TO ALL ROOTES GROUP DEALERS

SOFT TOP ASSEMBLY - SUNBEAM ALPINE

SERVICE BULLETIN NO. 191 (Con't.)

SUGGESTED MODIFICATION - SECONDARY BOW
To Relieve Soft Top Tension for Easier Closure.

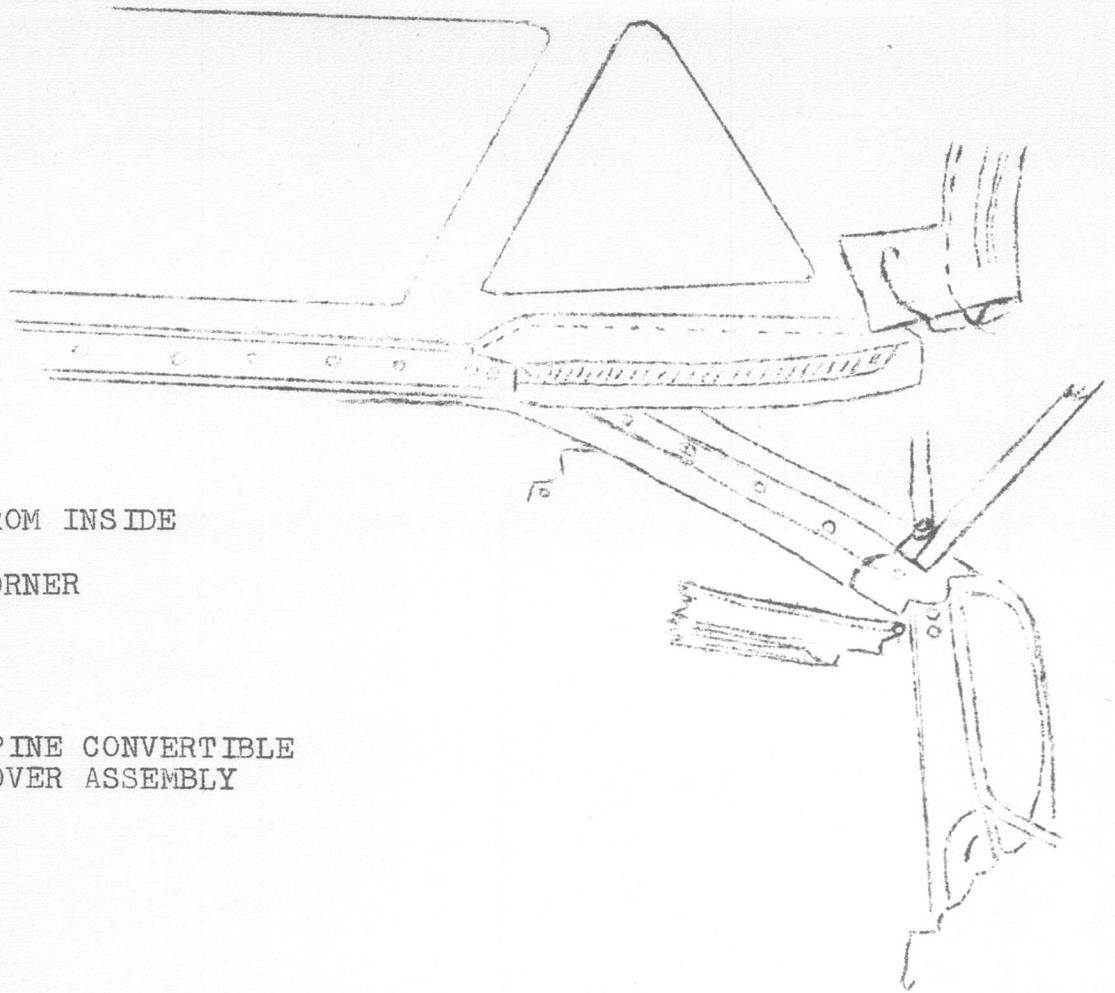
When cases of this nature are encountered it is suggested that the rivets in the secondary bow which attaches to the primary bow at the waist moulding be removed allowing the secondary bow to drop down. The Convertible soft top cover assembly should then be fastened properly to the header panel and the hasps adjusted for sufficient compression. The secondary bow then should be trussed back up to its original position when it can easily be seen new holes should be drilled in the secondary bow approximately 3/8" above the existing rivet holes and new rivets should be installed. This action will give sufficient relief to the soft top assembly to facilitate relatively less difficult fitting, especially in the case of women drivers.

1. Remove secondary bow C to main bow D attaching rivets A right hand side and left hand side.
2. Fasten soft top cover assembly to windshield header panel and secure with attaching hasps making sure of adequate compression of soft top cover header weatherstrip to windshield frame.
3. Adjust secondary bow to approximately same location on soft top cover as before making certain maximum play is removed from cover assembly without being drum tight when it can be determined where the rivet relocation holes can be drilled in the secondary bow B using as a guide the existing rivet holes in the main bow, both right hand and left hand sides.

It will be noted the distance between centers of the existing and relocated holes in the secondary bow (A - B) should be approximately 3/8".

4. Refit new rivets.

SUGGESTED MODIFICATION REPLACING ZIPPERS

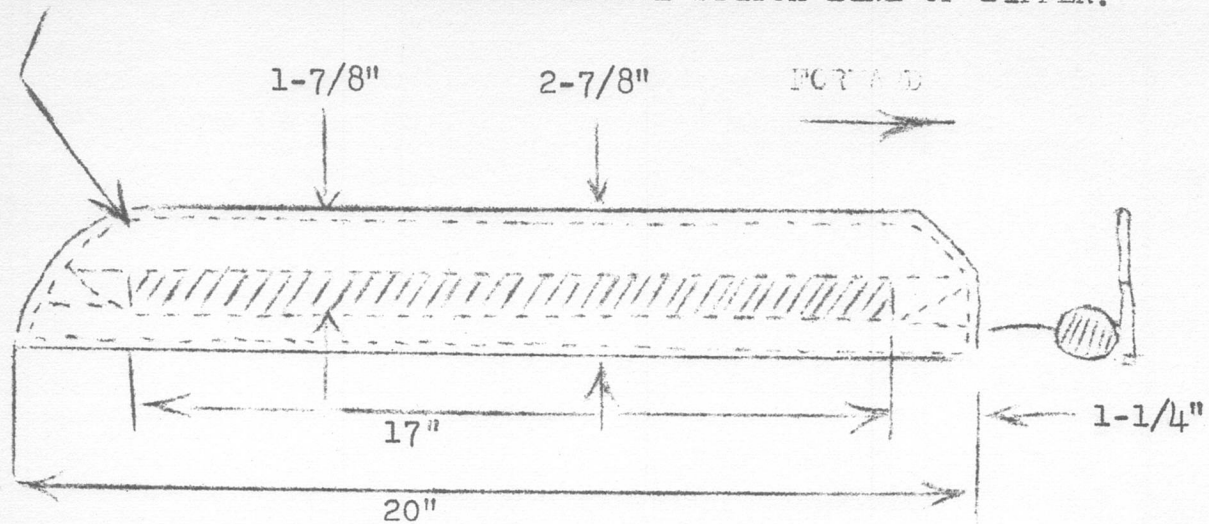
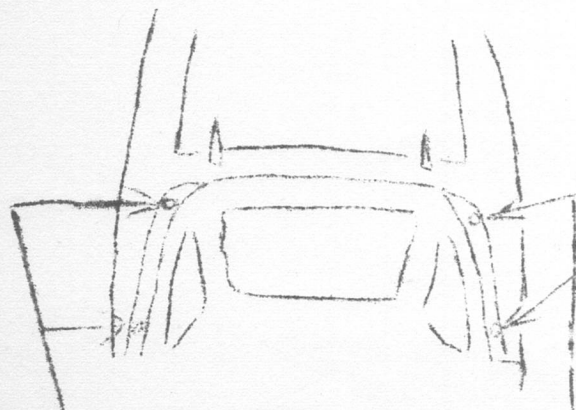
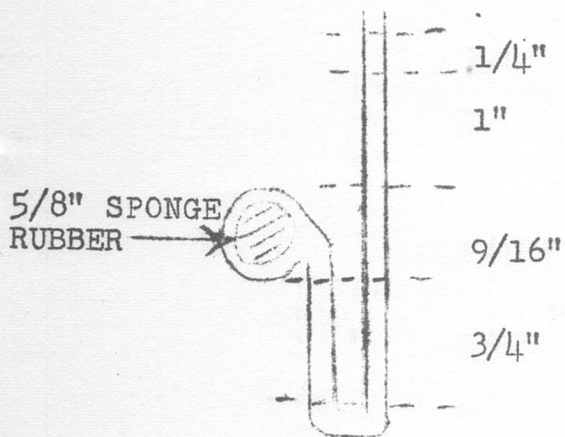
In cases where the zippers do become torn it is possible to effect a modification to the top cover assembly similar to our current production models which eliminates completely the zipper. This can be accomplished by:

- 1) Remove the existing zipper.
- 2) Sew to the existing zipper location a double-skinned piece

of black vinyl cloth similar to the soft top cover color.

- 3) Install within the double-skinned thickness welting the length of the periphery of the belt rail rear quarter section, making certain the welting is sewn on either side as evidenced in the sketch attached in such a manner that when the soft top stowage panels are put back in place the side stowage panel top cover compresses against the welting making an adequate water seal at the belt rail periphery.

There is also sufficient material on the top cover assembly to install two (2) dot fasteners to the body at the suggested points indicated in the sketch attached which should then render the modification quite acceptable.

1. Remove top cover.
2. Remove torn zipper sections from top cover as well as from periphery of belt molding.
3. Fabricate double skinned vinyl strips approximately 2-7/8" wide and 20" long and insert 5/8" welting the length of the strips between the skins and stitch on either side of welting to assure positive location. Note: Welting should be so located that when the side hood stowage panels are pressed in the closed position the edge of the stowage panel that abuts the body waist molding will compress against and atop the welting at all points along the periphery of the body waist.

4. The fabricated vinyl panels should then be sewn to the soft top cover assembly in the same location as was the previous zipper.
5. To insure removal of all soft top cover wrinkles which may present themselves in the locations of the rear quarter and rear vinyl windows, two dot fasteners should be installed on each side of the soft top cover with the reciprocal portion of the fastener installed in the outer body metal - per sketch attached.

STITCH TO TOP COVER ALONG ORIGINAL STITCH LINE OF ZIPPER.

DOT FASTENERS TO BE INSTALLED ON BODY.
